AFTON CREEK DEVELOPMENT
 Contingency Plans for 2020
 Prepared 12/11/2019 Revised 12/16/19

Memorandum

Re: Spring Contingency Plan and 2020 Work Activities

AFTON CREEK PRESERVE
 AFTON, MINNESOTA
 POND 5 GRADING PLAN

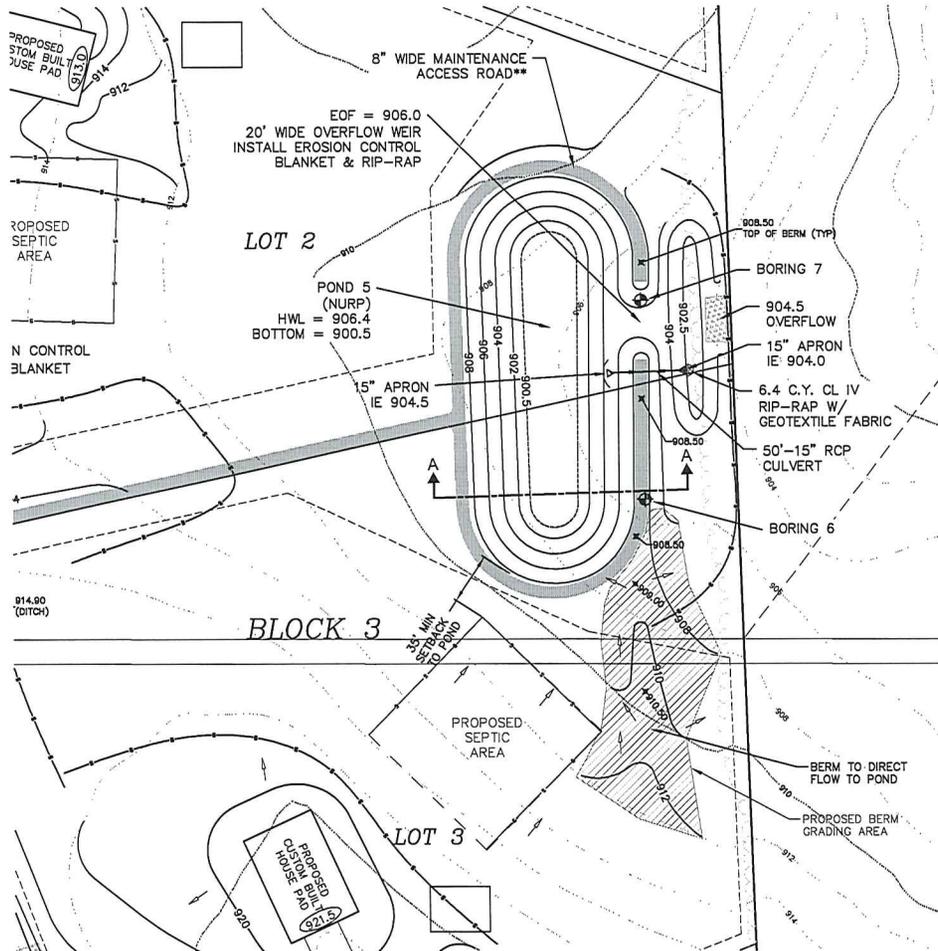
11. For the drawing indicating shaping work to be completed near the north side of the overflow berm at Pond 5; could you shade the area to be graded and indicate what elevation changes will be completed along with the measures planned for stabilization?

We have identified that additional grading is required on the south side of pond 5 to redirect runoff that is bypassing pond 5 and its adjacent overflow pond. Included with this contingency plan is a drawing showing the additional grading to be completed south of pond 5. This work will be completed once the frost has come out of the ground early summer of 2020. All disturbed areas will be reestablished within 7 days with appropriate seed within in compliance with our afore mentioned seeding plan-7 days.

We have identified that additional grading is required on the south side of pond 5 to redirect runoff that is bypassing pond 5 and its adjacent overflow pond. Included with this contingency plan is a drawing showing the additional grading to be completed south of pond 5. This work will be completed once the frost has come out of the ground early summer of 2020. All disturbed areas will be reestablished within 7 days in compliance with our afore mentioned seeding plan.

AFTON CREEK PRESERVE
AFTON, MINNESOTA
POND 7 GRADING PLAN

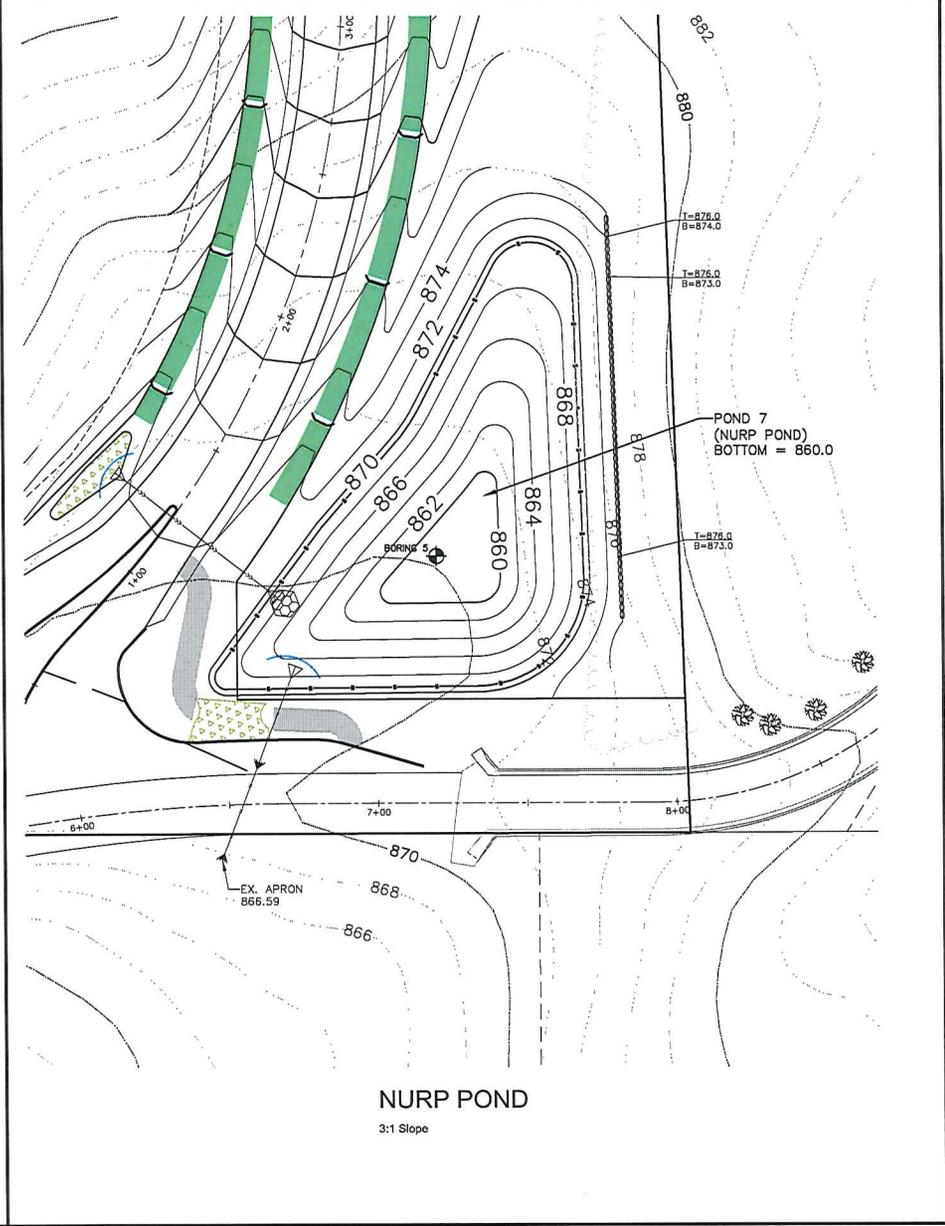
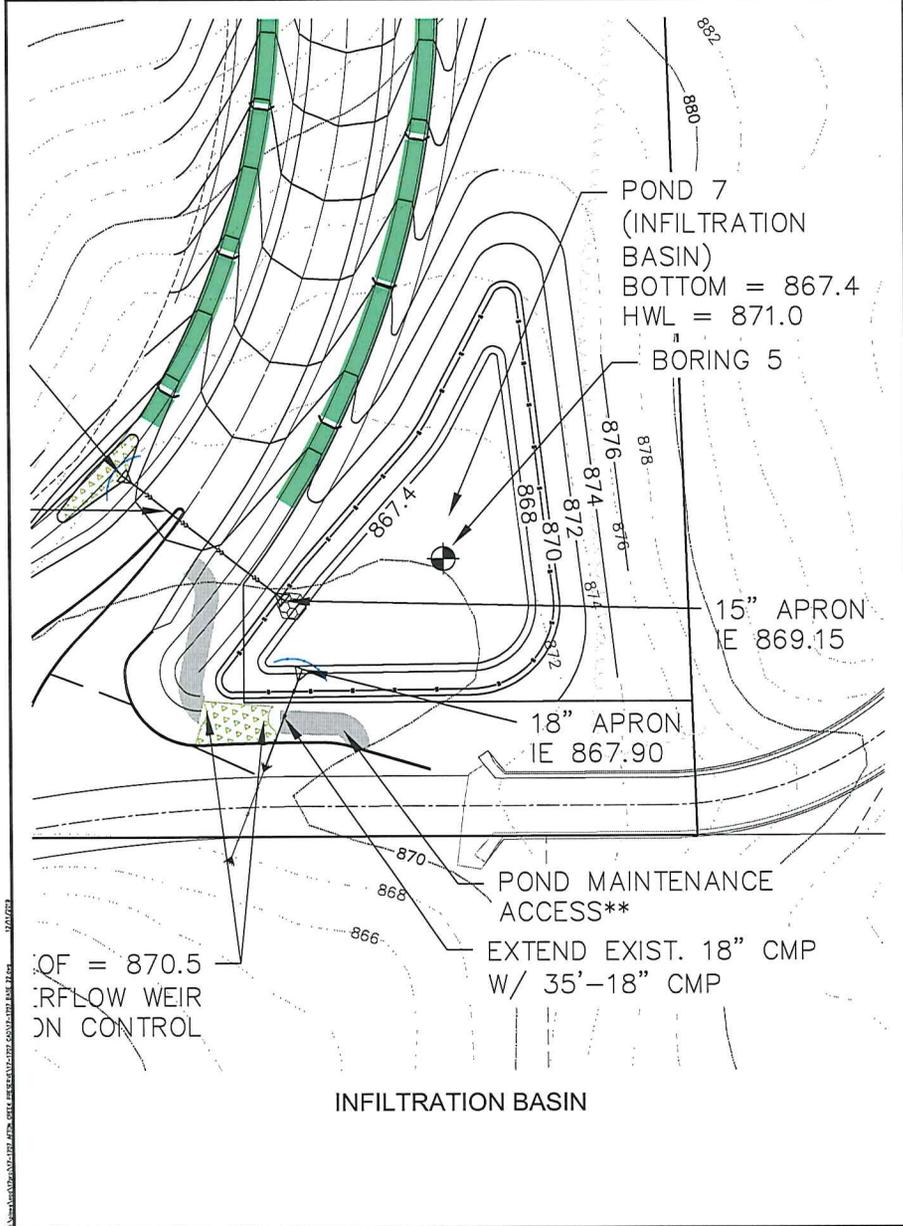
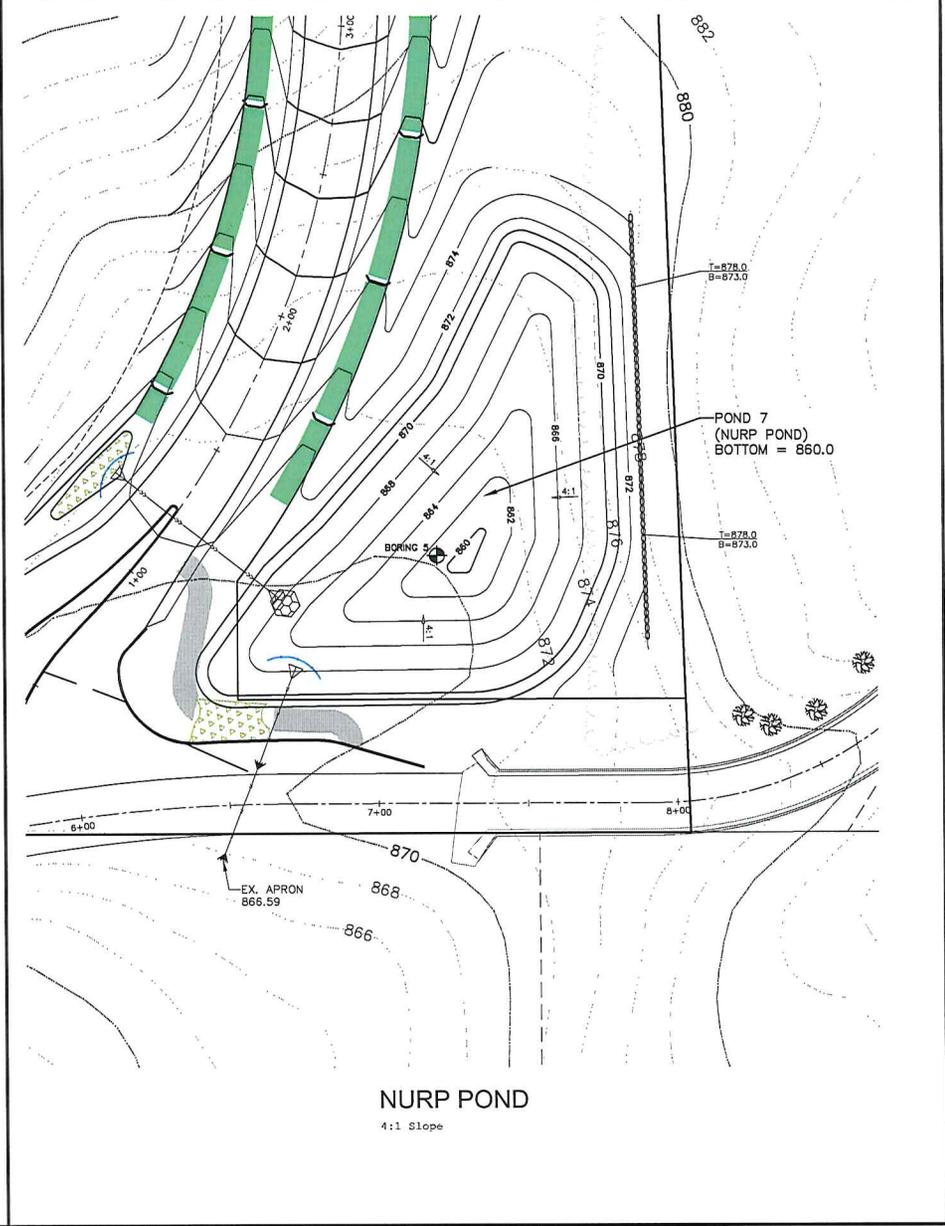
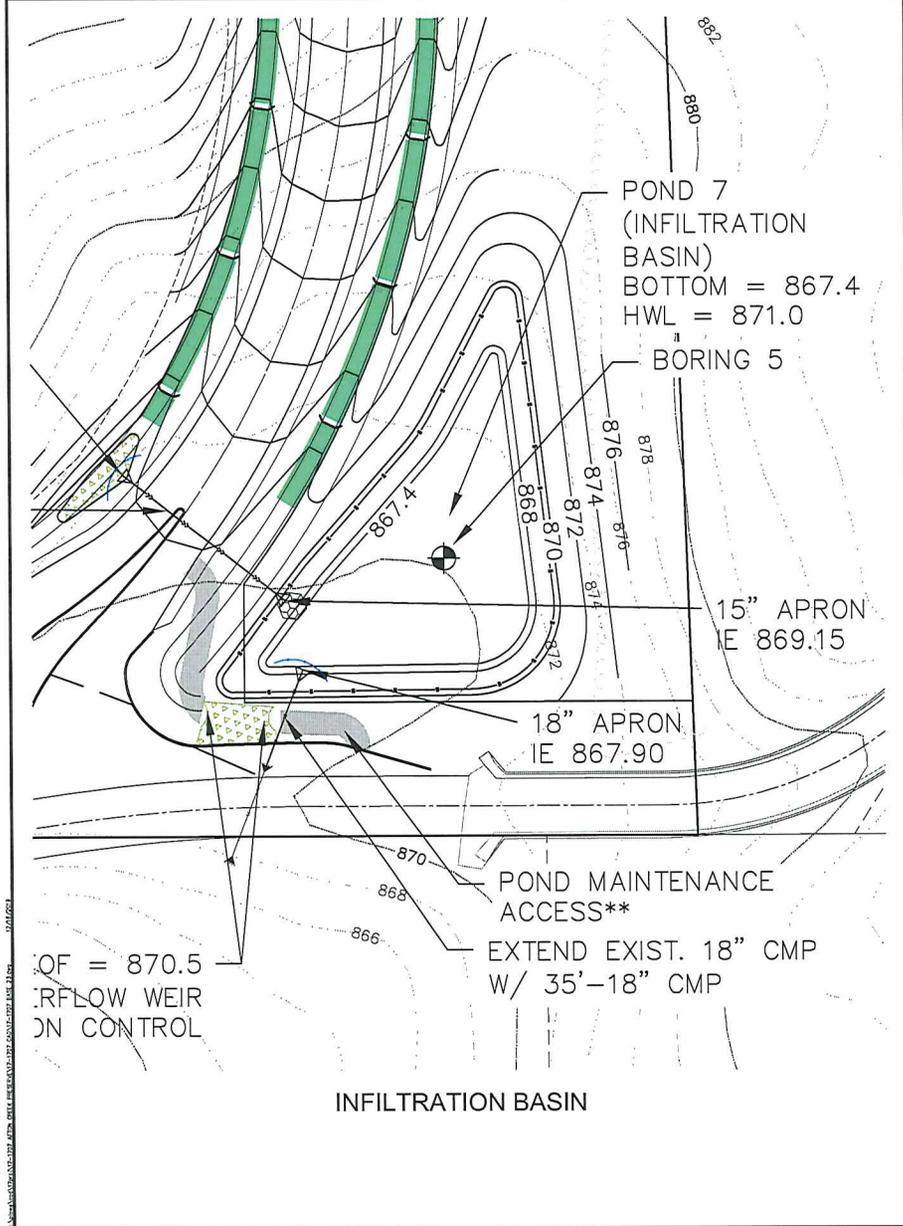
10. Under the memo regarding Pond 7 being developed into a wet pond:
 - a. Consider the size of the footprint needed to create 4:1 slopes, and how much land that would take – please state

- b. If the pond is this deep and side slopes would be 3:1; it is likely safety fence would be required to keep animals and people from entering the pond – please indicate

- c. It may be conducive to research increased likelihood for mosquito breeding habitat should this area be turned into a wet pond-Carlson team may wish to also state this in more detail

We have reviewed an option of wet pond (NURP POND) for Pond 7. A drawing is attached that shows the area and depth needed to meet the required dead storage volume of runoff for the 2.5" rainfall event.

Required volume below the culvert outlet elevation = 32,452 cu. ft.
Volume provided in the attached plan = 33,100 cu. ft.

- 8 ft. depth from NWL (Existing culvert elevation)
- Move easterly closer to adjacent property
- Construction of a minimum 3 ft. high retaining wall that would be 16 feet above the pond bottom
- A vehicle access maintenance road along the east and north sides is not feasible
- Pond side slopes are 3:1; Other on-site project NURP ponds are 4:1 or flatter slopes.
- There may be some safety concern due to the pond depth, slopes, retaining wall and location next to Oakridge Trail South and 60th Street

It is our opinion; this would not be a preferred option if an alternative to the current pond 7 is required.
